## INTRODUCTION

Since the introduction of the THM 440-T4 Transaxle in April, 1984, there have been many major engineering design changes. These changes have affected nearly every part used in the THM 440-T4. This Update Handbook will explain each change, the parts affected by the change, and any parts interchangeability problems created by the change.

### THM 440-T4 PUMP INFORMATION

Figure 23

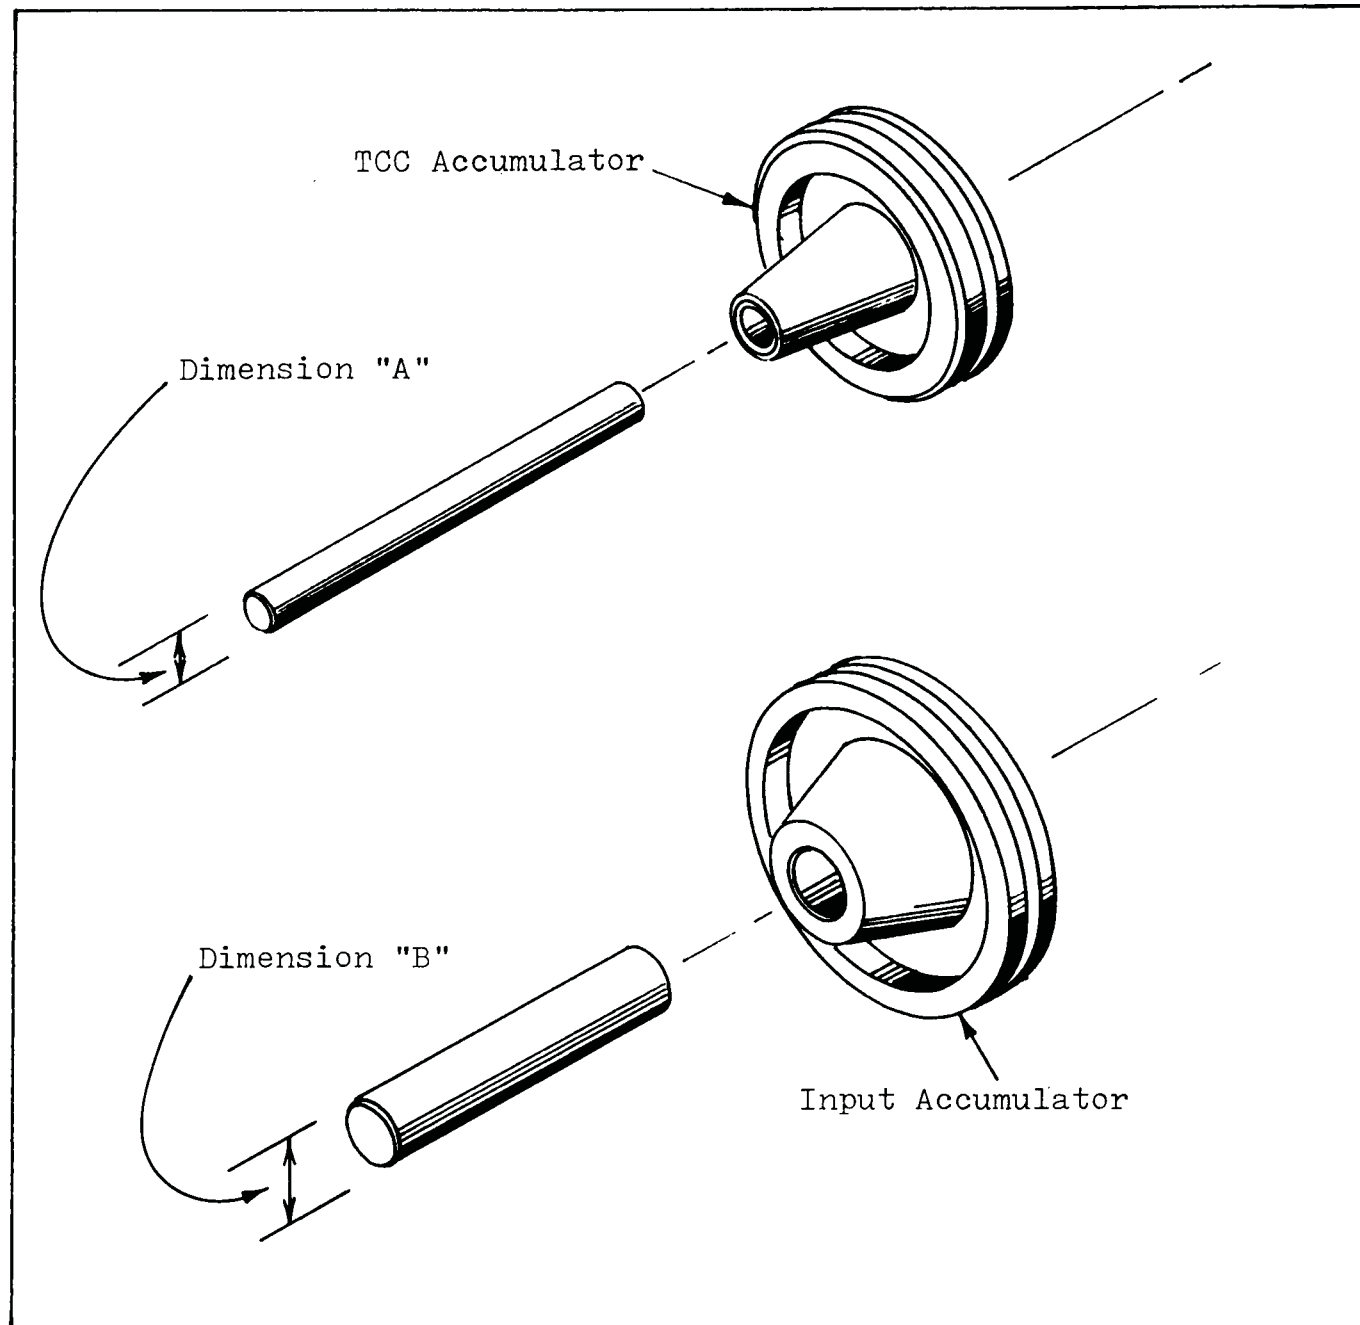
In mid 1985 the dimensions of both the TCC accumulator pin and piston, and the input accumulator pin and piston changed. We have included the dimensions of both early and late for identification purposes. (See Figure 23).

Obviously you would not be able to install the late pin into the early piston, but you could go the other way very easily. Make sure you measure these pins and "Always" up-date to the larger 2nd design.

Figure 24

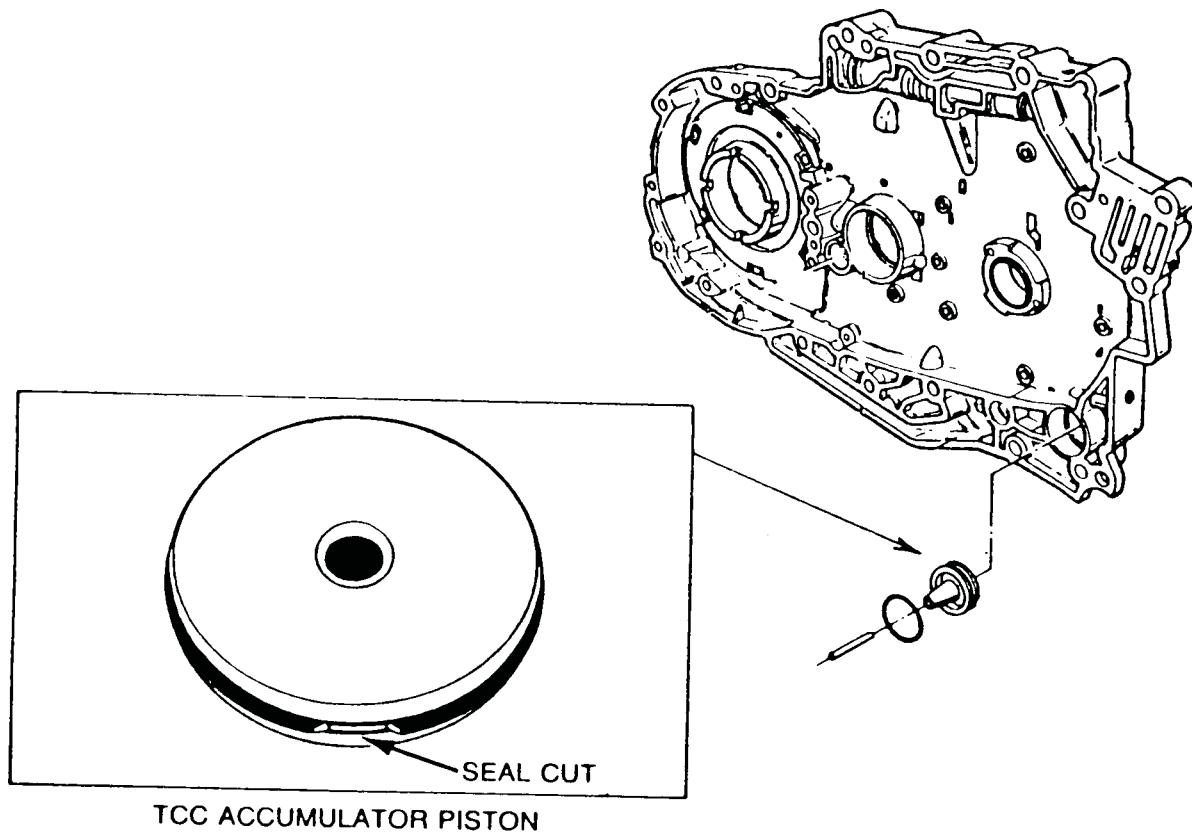
CAUSE: Some 1984 and some early 1985 THM 440-T4 transaxles may experience a no Torque Converter Clutch (TCC) apply or TCC shudder condition, which may be due to a cut or rolled TCC accumulator piston seal (See Figure 24).

CORRECTION: Install updated service package 8646926.  
Updated service package 8646926 contains the following:

Figure 26

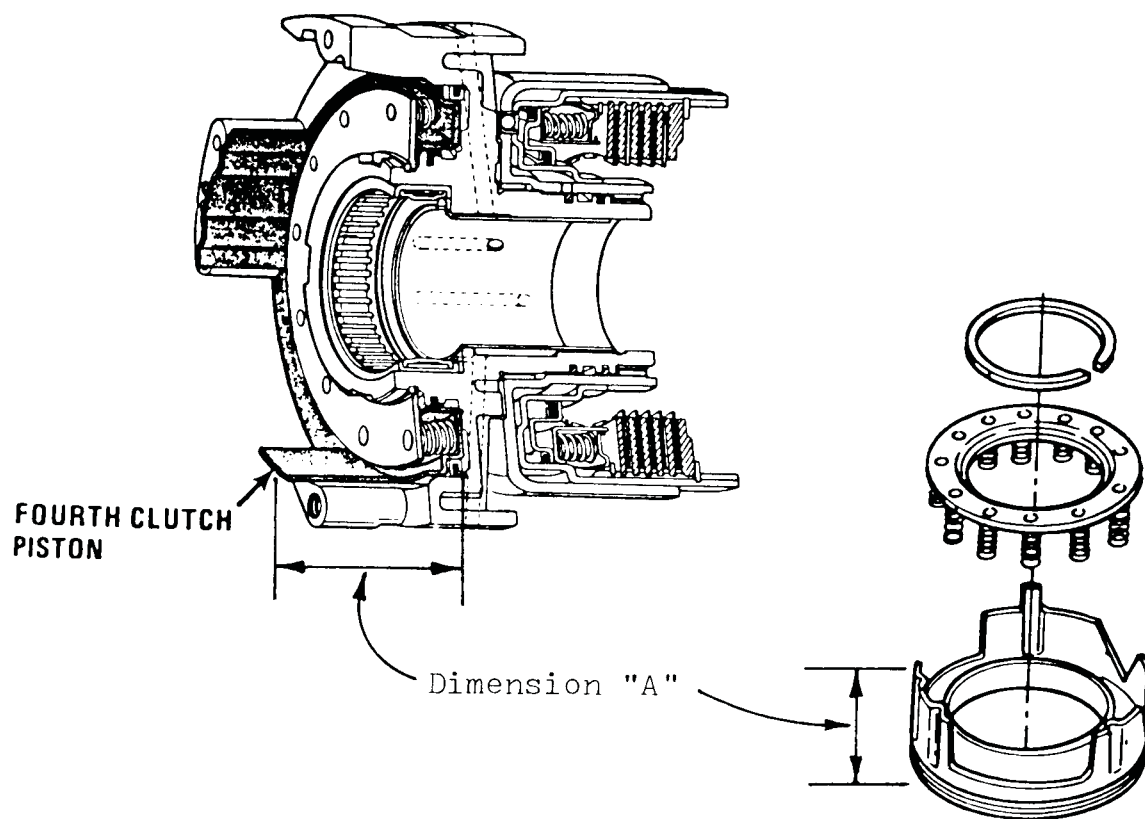
To identify, use a dial caliper set, and locked, at 1.930" and check as shown at dimension "A" in Figure 26. If dial caliper will go over the top of the piston, you have the late style piston.

If the dial caliper will not go over the top of the piston, the 4th clutch piston will have to be replaced with OEM part No. 8658388.

If not put together with compatible parts, the fourth clutch will burn immediately.

Figure 33

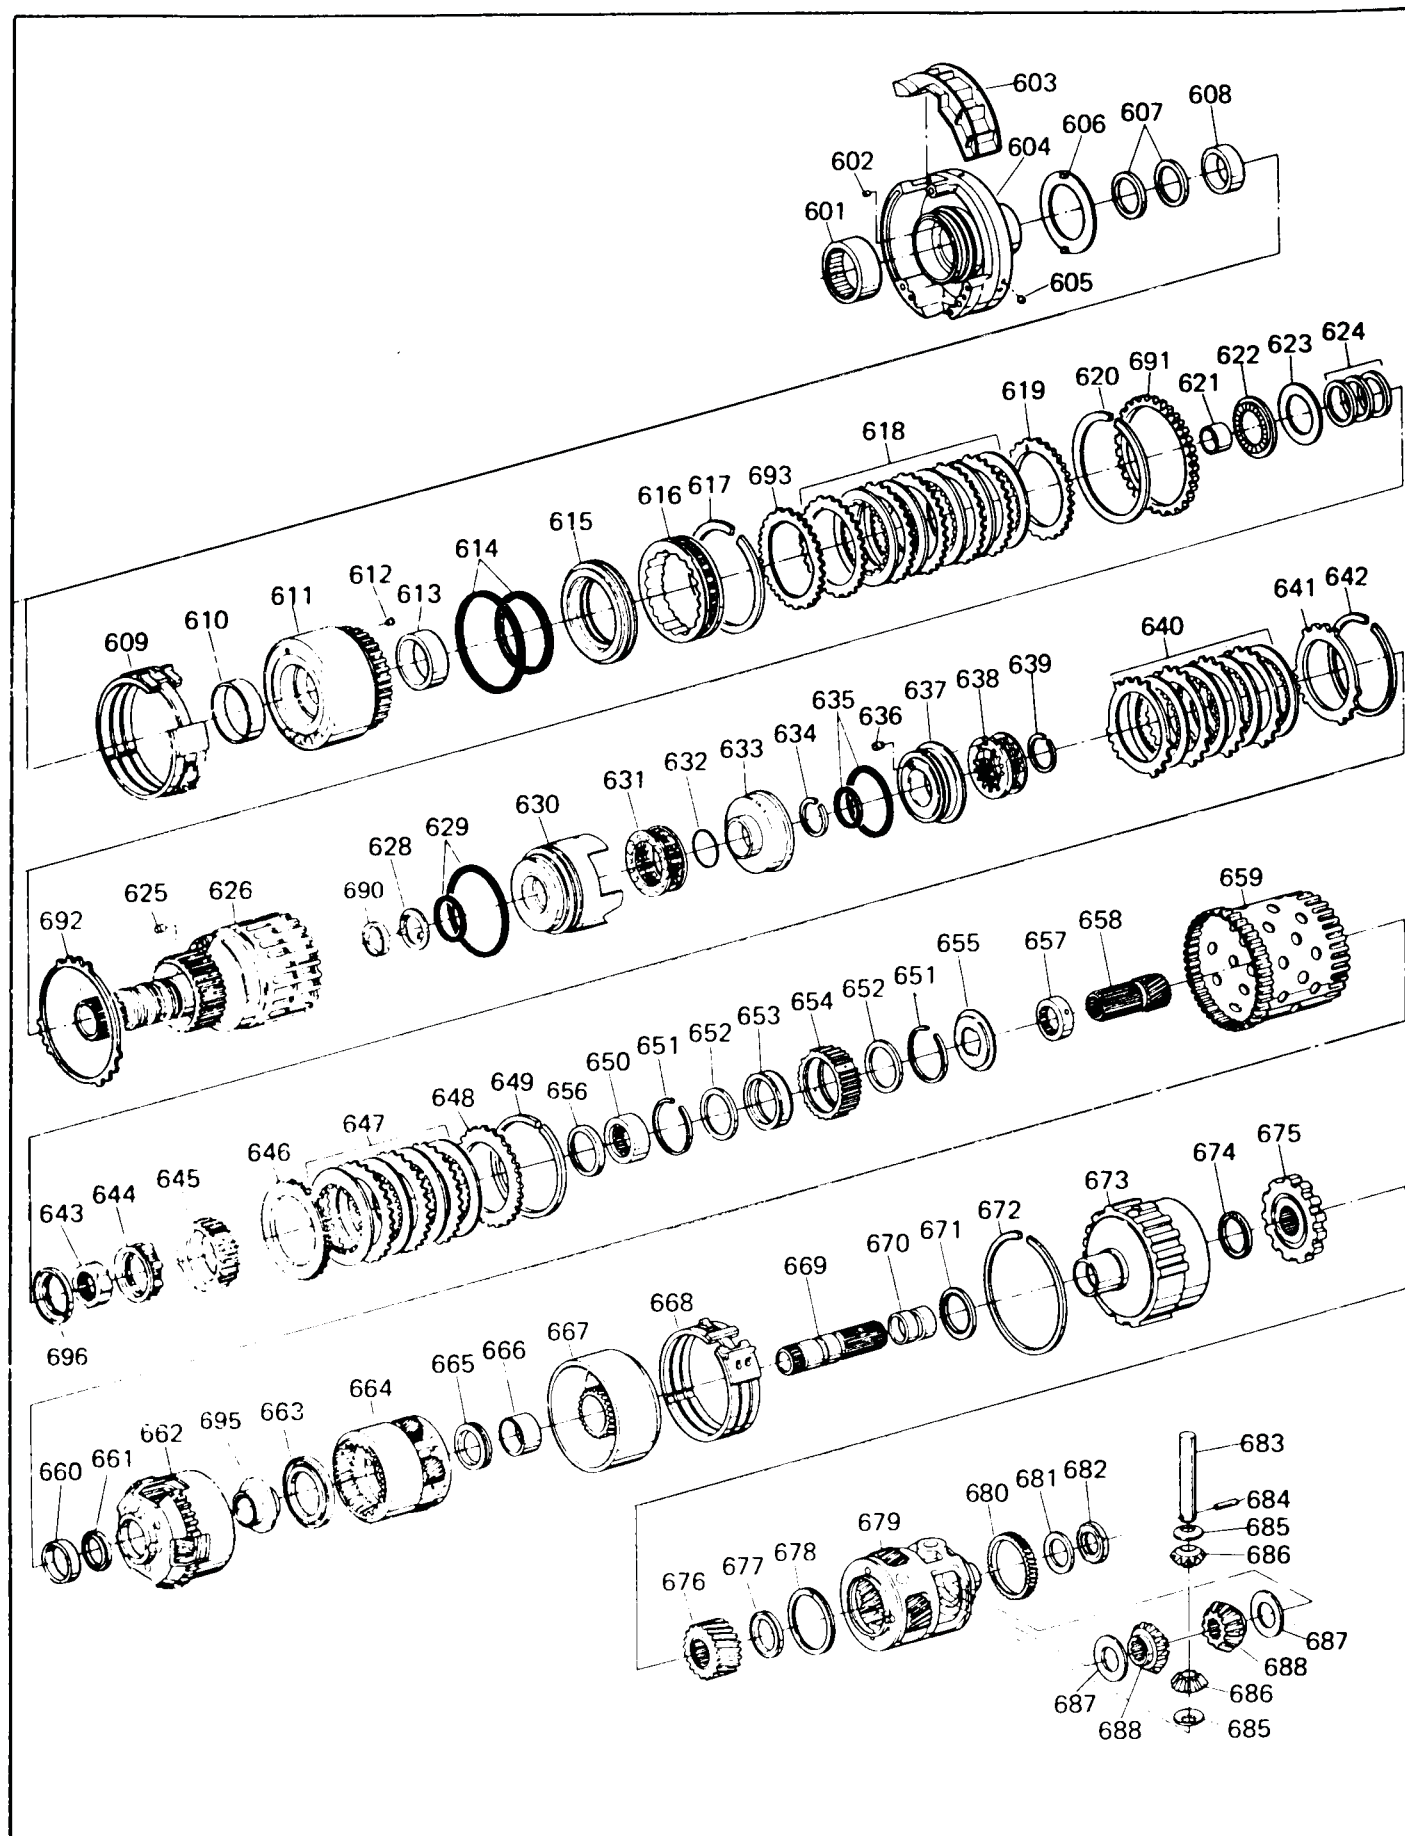
- 5) Reverse Reaction Plate(692) - Eliminated. If the redesigned backing plate assembly is used, you can eliminate the reverse reaction plate(692) Figure 33.

Figure 34

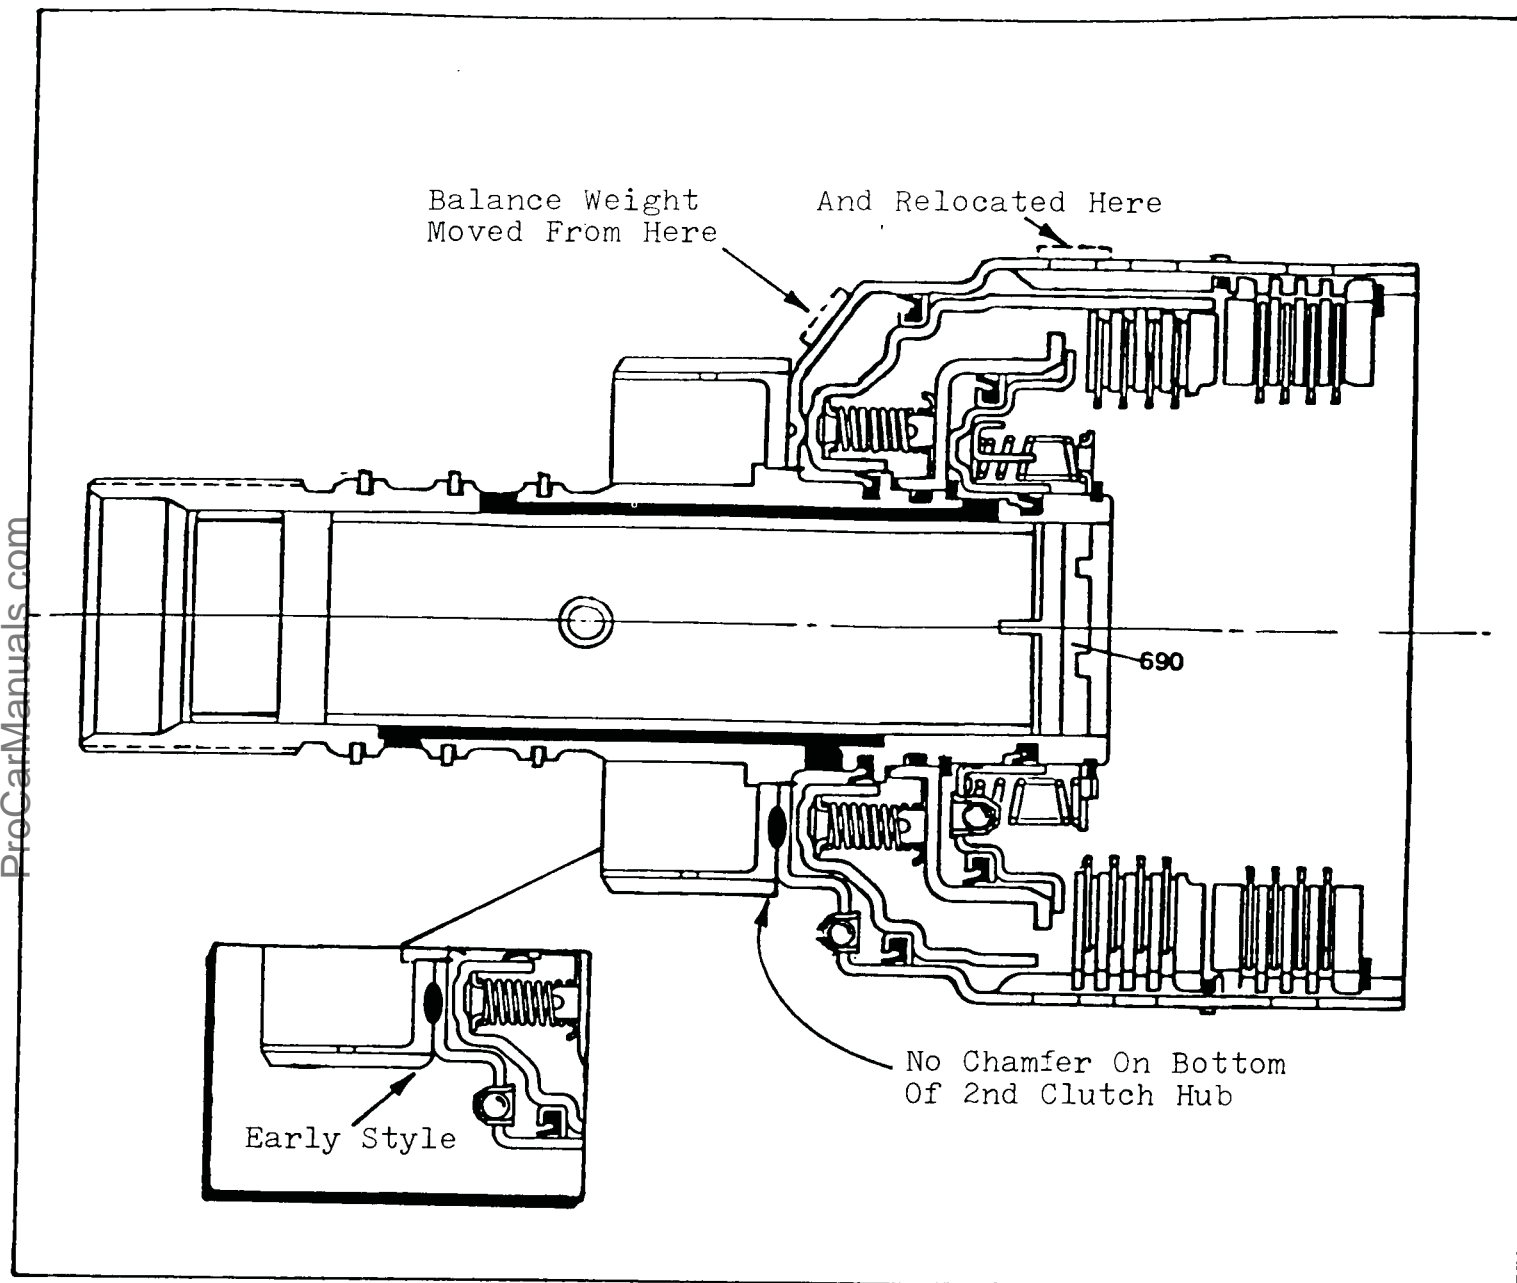
- 6) Input Housing - Revised balance weight location so as to eliminate interference with revised backing plate assembly (See Figure 34). Also no chamfer on bottom of 2nd clutch hub (See Figure 34).

The 6 plate 2nd clutch will retro all the way back as long as you have an input housing with no balance weight, or an input housing with the balance weight down on the side (See Figure 34).

Figure 35

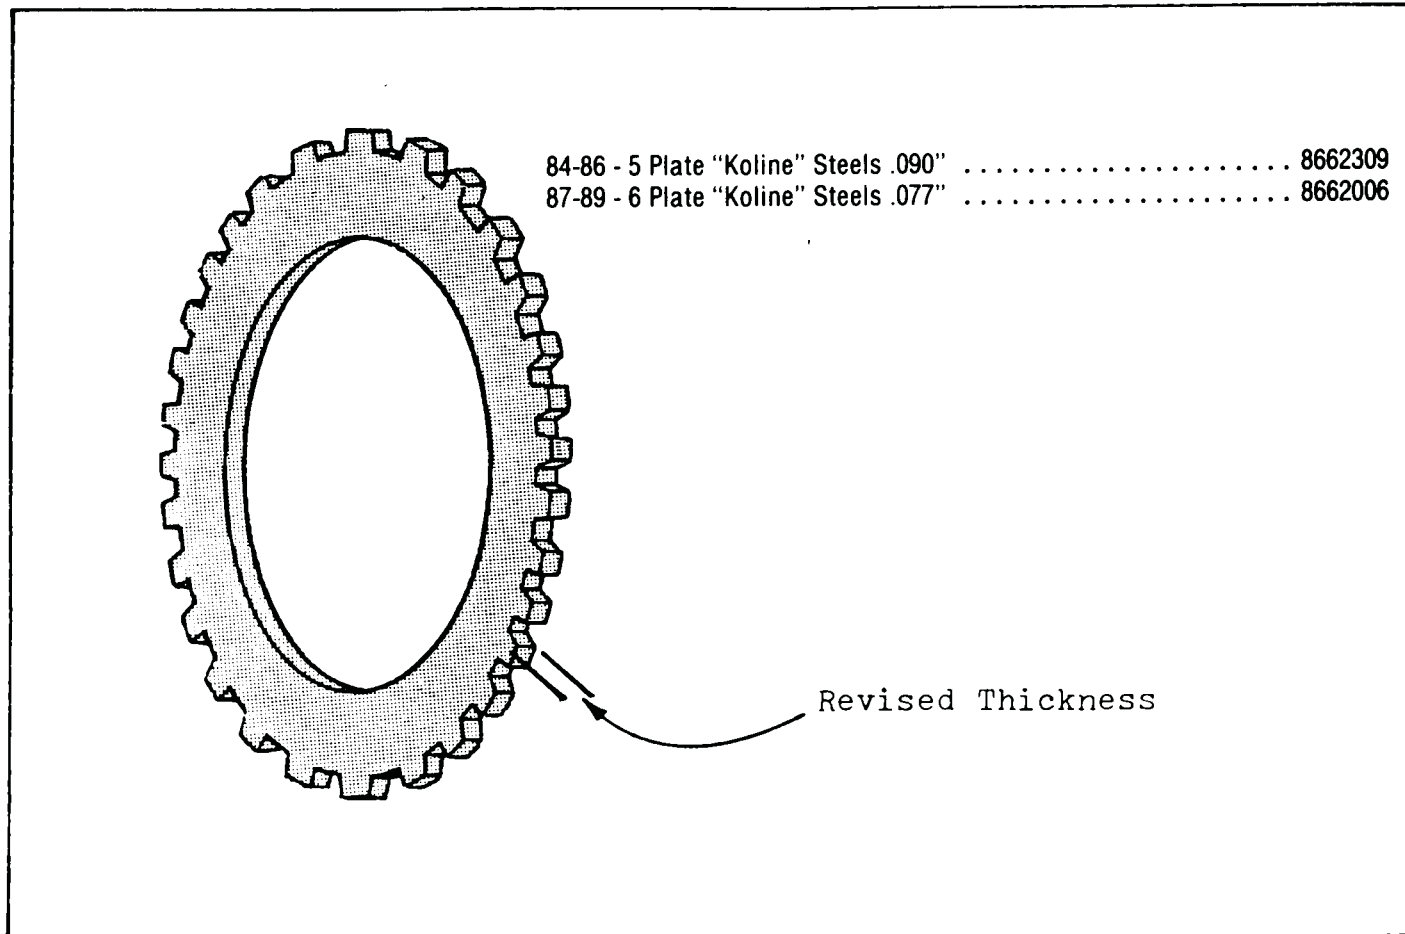
- 3) "Koline" Steel Clutch Plates - Revised thickness, (See Figure 35).  
84-86 - 5 Plate "Kolines"---.090"  
1987 - 6 Plate "Kolines"---.077"
  - 4) Backing Plate - Redesigned to incorporate backing plate(619), support ring(691), and snap ring(620) into one assembly. (See Figure 32).

The steel plates in the 440-T4 2nd clutch are unique, in that they are black in color. They have a black coating on them called "Koline" plating, for shift pleasability (See Figure 35).

The thickness of the "Koline" plates were revised for 1987, with the addition of the 6 plate 2nd clutch pack (See Figure 35).
